Slides for Comments to Fort Bragg City Council

February 26th, 2018

Figure 2B: Straight line route of a daylighted Alder Creek, might be too steep to handle the Head, and the “Fire Station Meander” route based on topography, along with excavation of the Eastern edge of the Ramp:

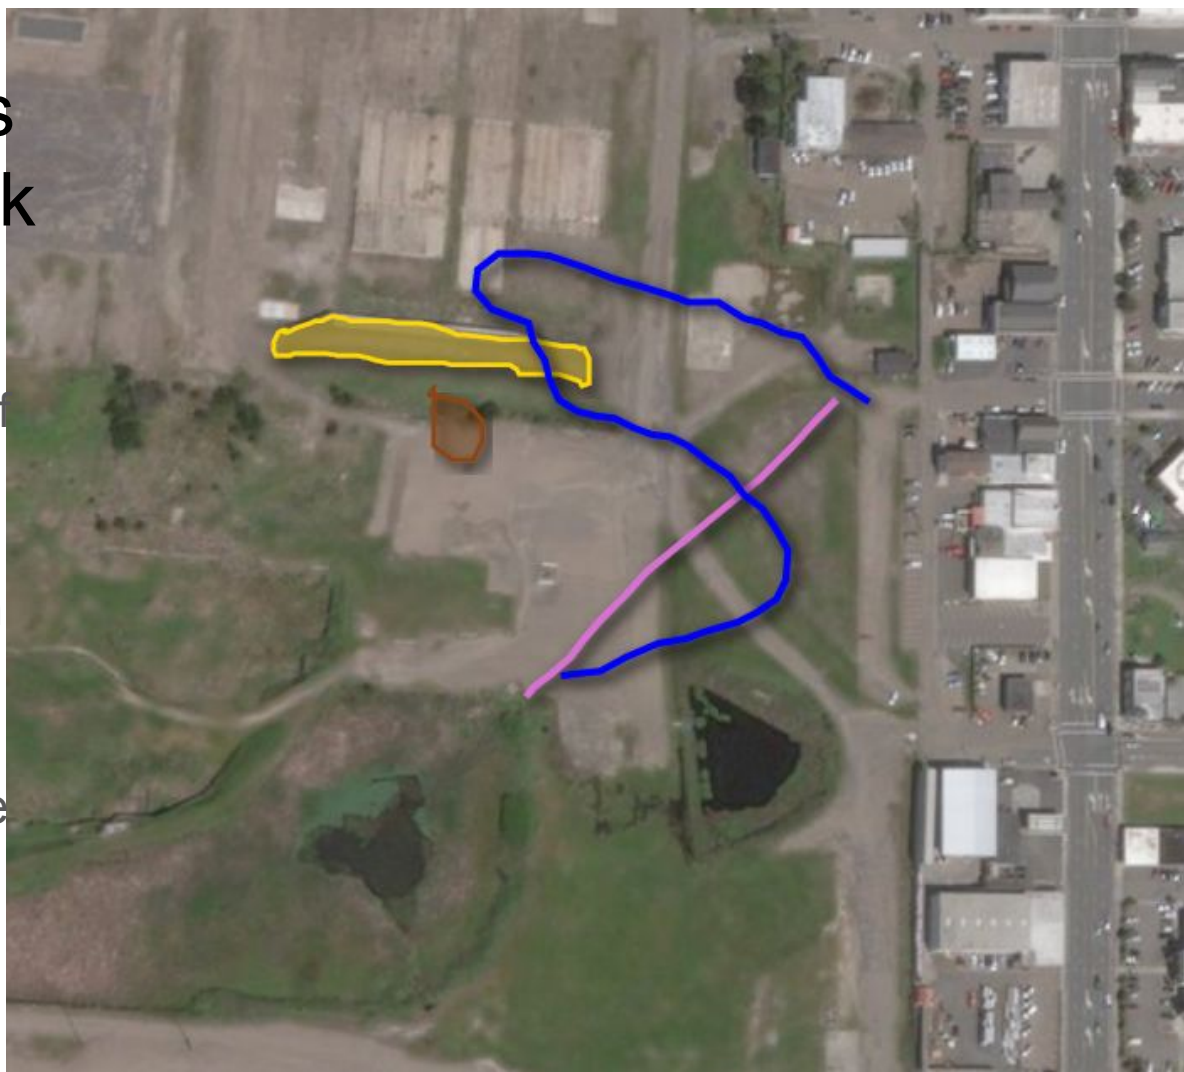
2) Keep our Options open for Alder Creek Daylighting

The previous features overlaid with Alternative 1

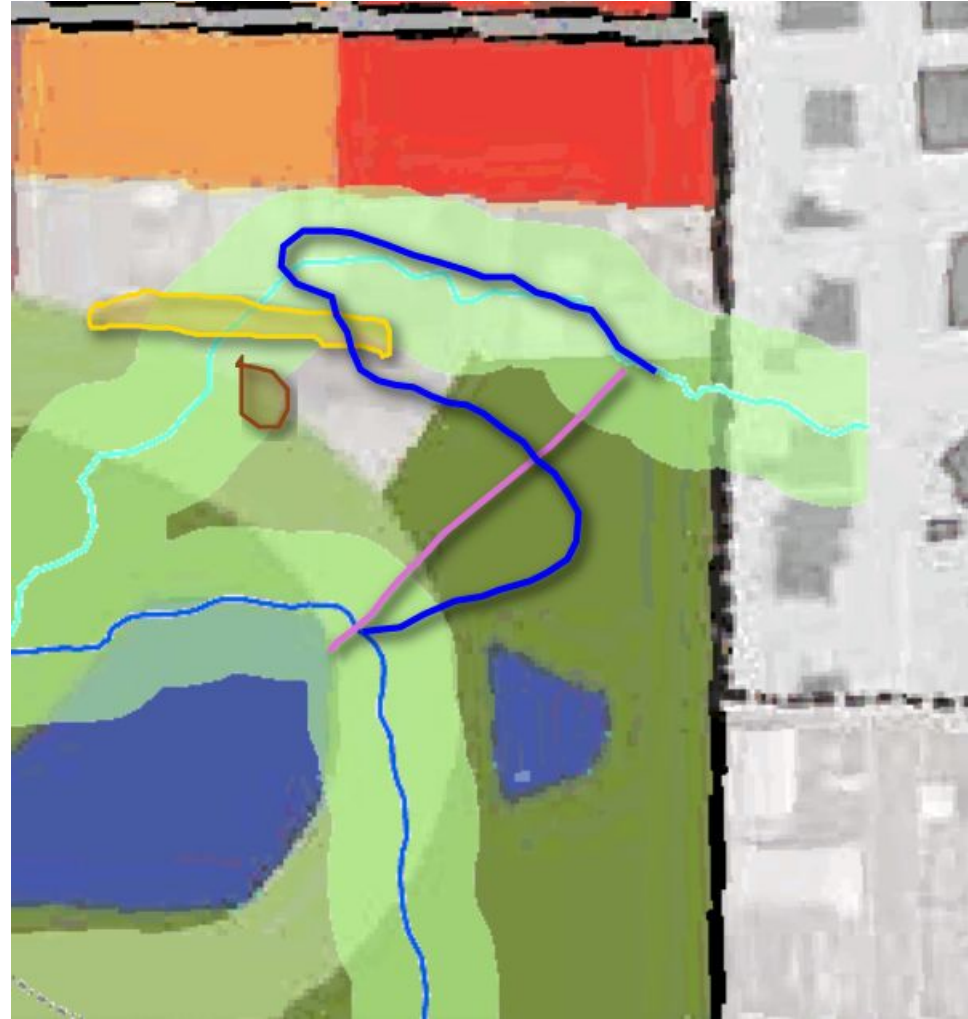
2) Keep our Options open for Alder Creek Daylighting

3) City Square should be surrounded by either CBD and/or ocean view.

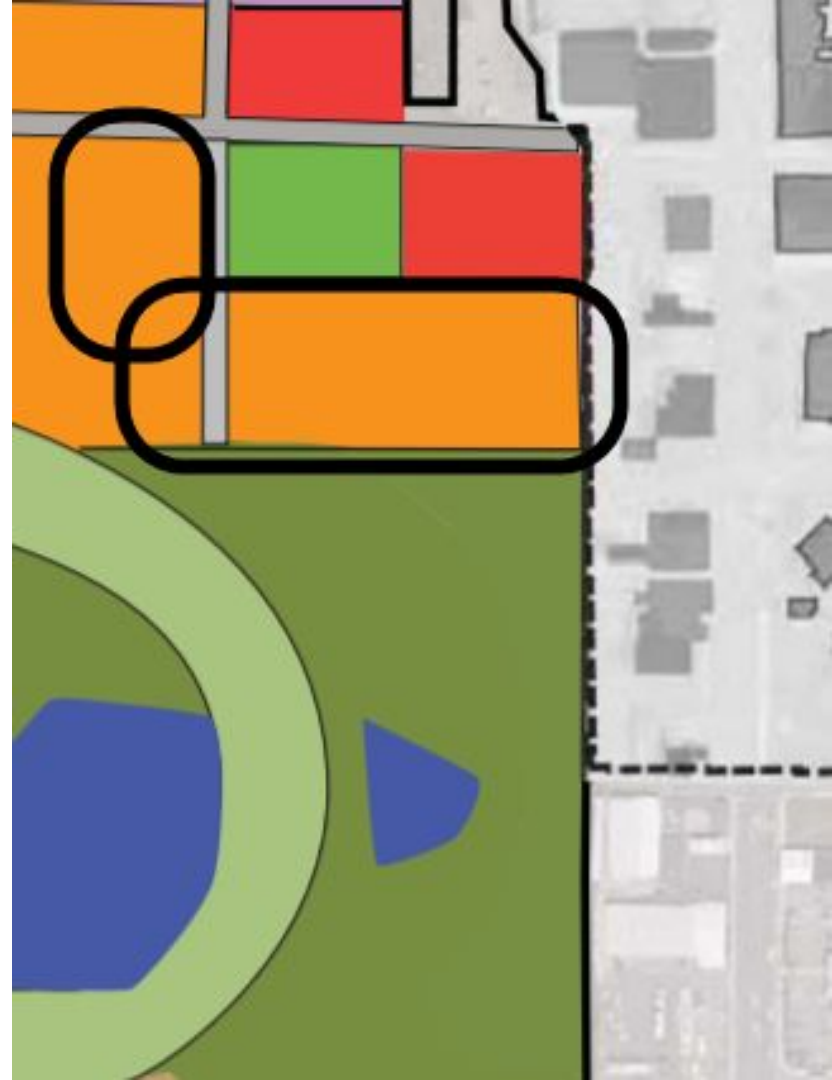
Please visit Healdsburg Town square next time you are driving by.
